# ERC Series Remote Condenser - Horizontal Coil Type

Bulletin Number: PS - 3 - 98

## SERVICE BULLETIN

### Subject: ERC301 Fan Motor

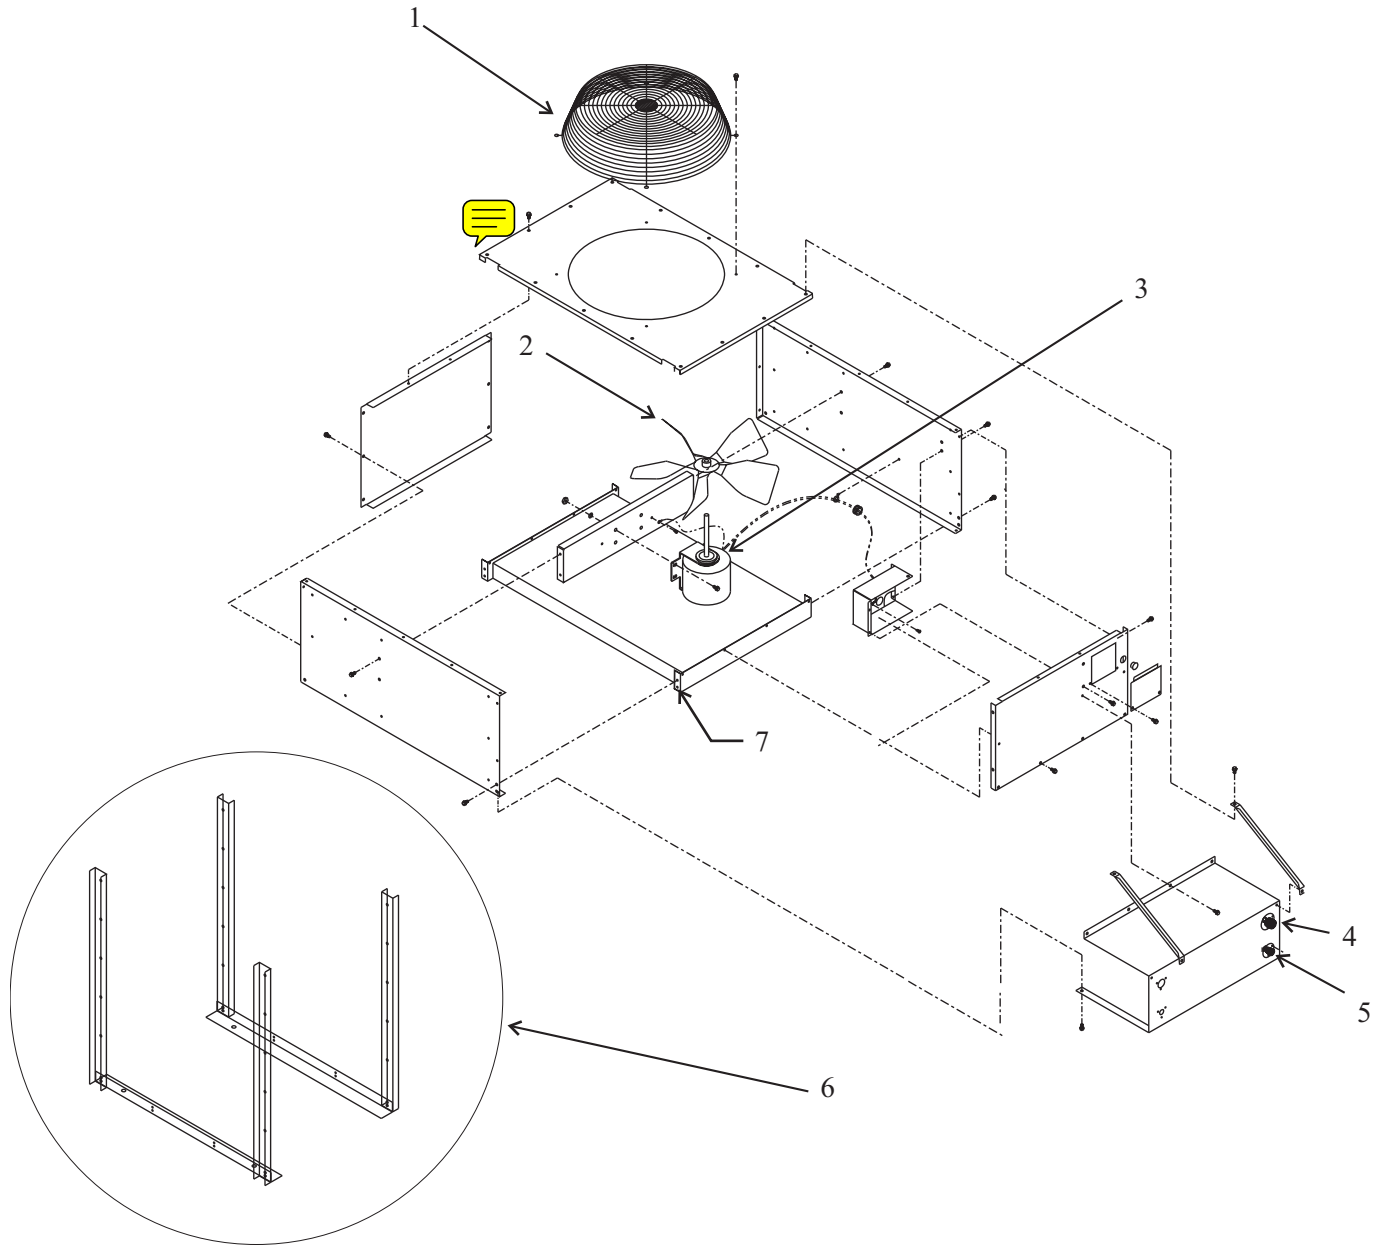
Effective with serial number 103236-10B, the ERC301 remote condenser is being manufactured with a one-third H.P. fan motor instead of the prior one-quarter H.P. motor.

The part number for the new motor is: **18-8797-32**.

Although the ERC301 is the only condenser manufactured with the one-third HP fan motor, the 18-8797-32 motor will be used as a common replacement for ERC151, ERC201, ERC302, ERC401, and ERC402 fan motors.

**Note: Fan motors shipped and ERC301 condensers built after 11/1/98 have a shorter shaft. The fan blade mounts flush to the end on those motors. A quick check is that the "flats" on the motor shaft are now  $1\frac{5}{8}$ " long and they were  $2\frac{1}{2}$ " long.** When the longer shaft one-third HP motor is used, position the fan blade  $\frac{7}{8}$ " in from the end of the motor shaft.
